MATRIX	Service Bulletin	
	Matrix TreadMill Tread Sense function is released	
Effective Date: Nov. 10, 2014	Models Affected: All Matrix Treadmills; T5x, T7xe, T7xi	Bulletin Number
Prepared by: Eric Chen		NB-1411010

A belt stop feature called “Tread Sense” will be released on all Matrix treadmills. If no footfalls or user interactions with the console are measured, a warning message will display on the console. A 10 second countdown will begin and the belt will stop, ending the program.

T7xi:

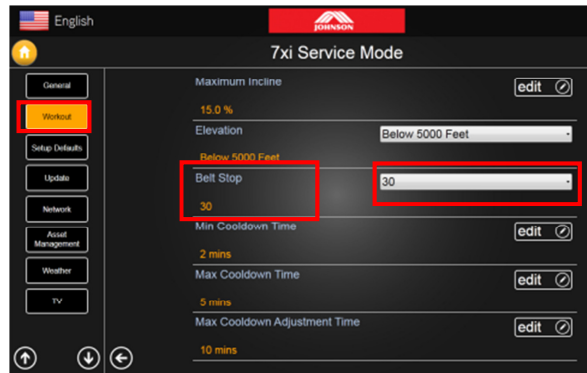
- Step 1: Enter Service Mode by pressing ‘enter, 3, 0, 0, 1, enter’.
- Step 2: Select ‘Workout’.
- Step 3: Select ‘Belt Stop’.
- Step 4: Set up time for “Tread Sense” function.

T7xe:

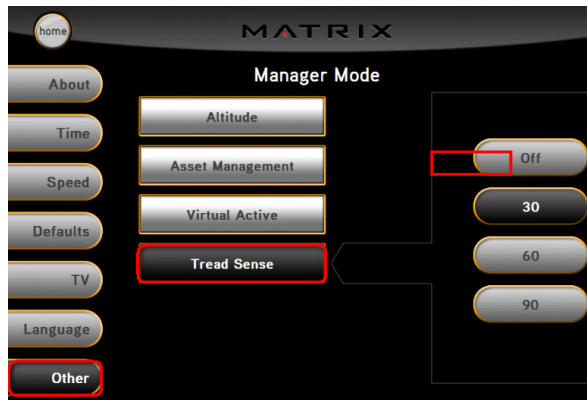
- Step 1: Enter manager mode by pressing ‘enter, 1, 0, 0, 1, enter’.
- Step 2: Select ‘Other’.
- Step 3: Select ‘Tread Sense’.
- Step 4: Set up time for “Tread Sense” function.

5. When Tread sense is “ON”, how to do the running test after the installation?

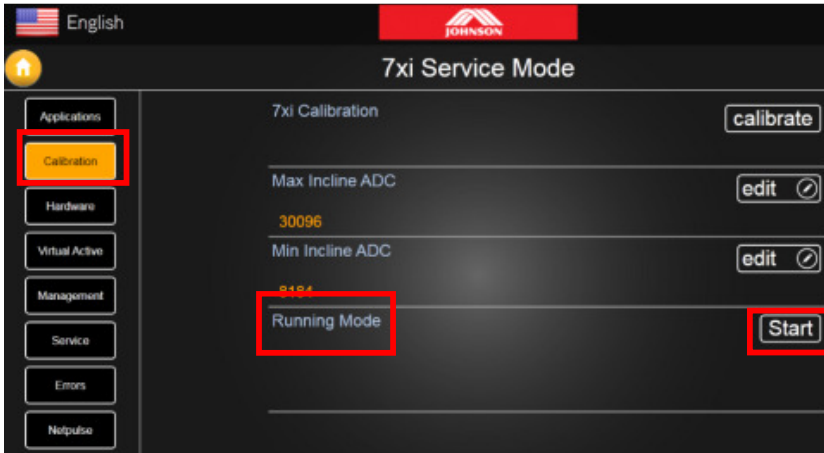
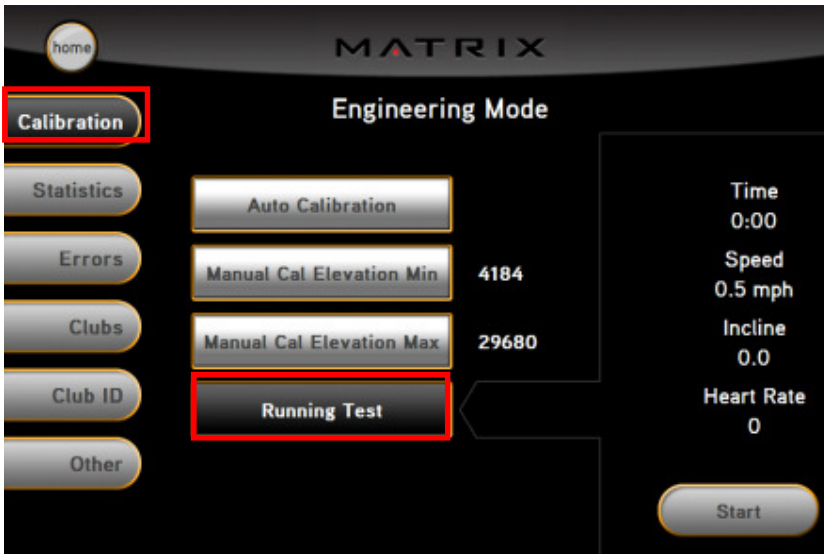
To solve the installing issue like adjusting the belt, JHT has added a “Running test” function on the engineer mode, which allows installers to do the belt adjustment and test. Also this function will not stop until press Stop or exit the mode, it will provide customer for demonstration and other functions.

T7xi:
Check and set up “Running Test” function.
Step 1: Enter Service Mode by pressing ‘enter, 3, 0, 0, 1, enter’.
Step 2: Select ‘Calibration’.
Step 3: Select ‘Running Mode’.
Step 4: Select ‘Start’ to run the belt.

T7xe:
Check and set up “Running Test” function.
Step 1: Enter Engineering mode by pressing ‘enter, 2, 0, 0, 1, enter’.
Step 2: Select ‘Calibration’.
Step 3: Select ‘Running Test’.
Step 4: Select ‘Start’ to run the belt.

T5x:
Check and set up “Running Test” function.
Step 1: Press & hold INCLINE DOWN and SPEED DOWN keys to enter Engineering mode.
Step 2: Select ‘Running Test’.
Step 3: Press go key to run the belt.
